Answer to Reviewer 1 : gmd-2017-297-RC1

Answer to Reviewer 2 : gmd-2017-297-RC2

Fig. 1. Schematic diagram for the nesting configuration. The upper panel gives an example of the spatial distribution for the 4 models and the lower panel shows the nesting of the time-steps

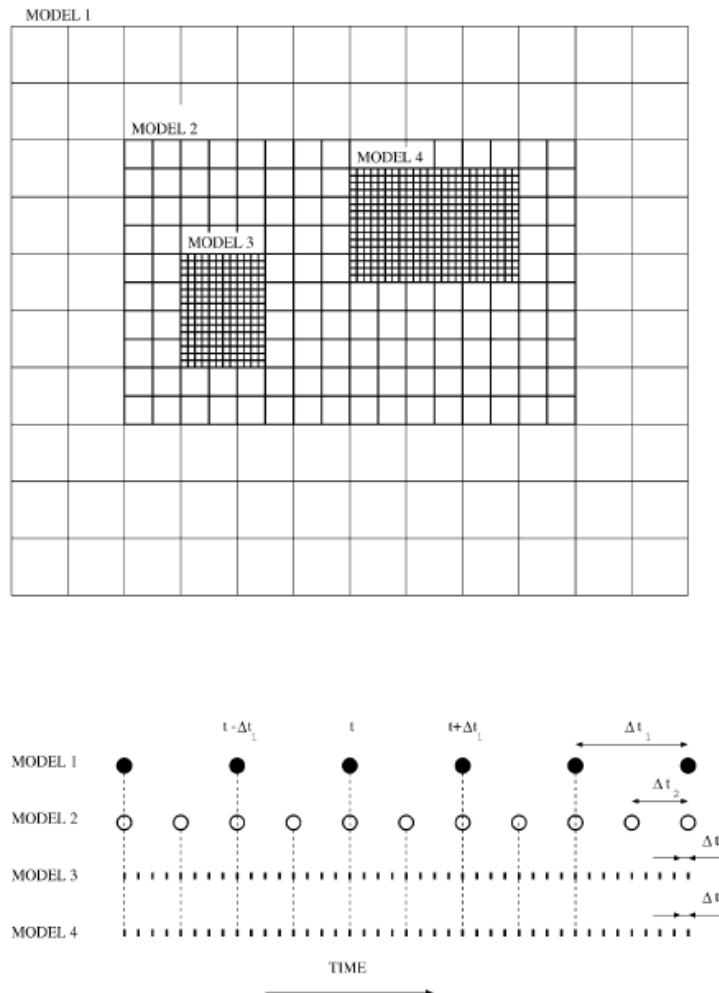
1) section 2.1: with the two-way interactive nesting, what frequency of updating do you typically use both to provide the boundary forcing for the “son” and also the upscale relaxation for the “father”? These details should be given in the examples cited later in the paper.

Spatial interpolating is performed only when the two models are synchronized in time. So the exchange of information between the nested models occurs at each coarse mesh model time step, as illustrated in the figure below from Stein et al. (2000). This has been added in the text.
